Model	Applicable To	File Under	Bulletin No.
1997 PRELUDE	ALL with A/T Thru VIN JHMBB6 . . . VC012298	TRANS	97-029
			Issue Date MAY 1997

MIL Stays On After Starting / DTCs P1768 and P1773

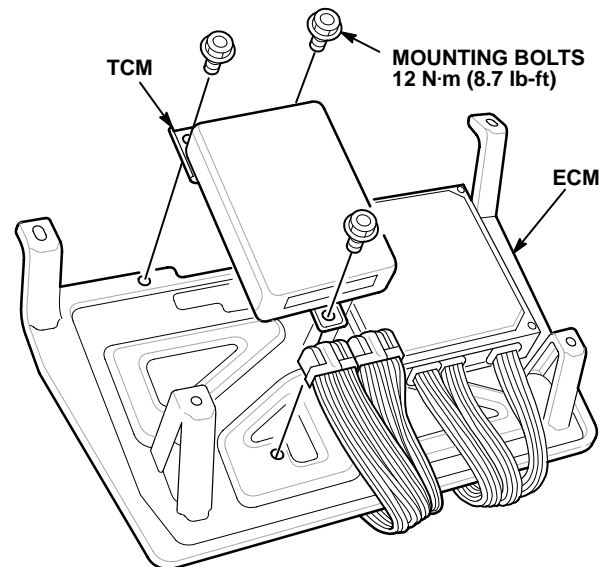
1. Remove the passenger's side door sill molding.
2. Pull the passenger's side carpet back to expose the ECM cover.
3. Remove the ECM cover mounting nuts, then turn the ECM cover over.
4. Remove the TCM by disconnecting the two connectors and removing the three mounting bolts.

5. Install the new TCM in the reverse order of removal, and reinstall all removed parts.
6. Record the customer's radio station presets, and the radio anti-theft code.
7. Pull the BACK-UP (10 A) fuse from the under-hood fuse box for 10 seconds to reset the ECM and the TCM.
8. Enter the radio anti-theft code and the customer's radio station presets. Reset the clock.
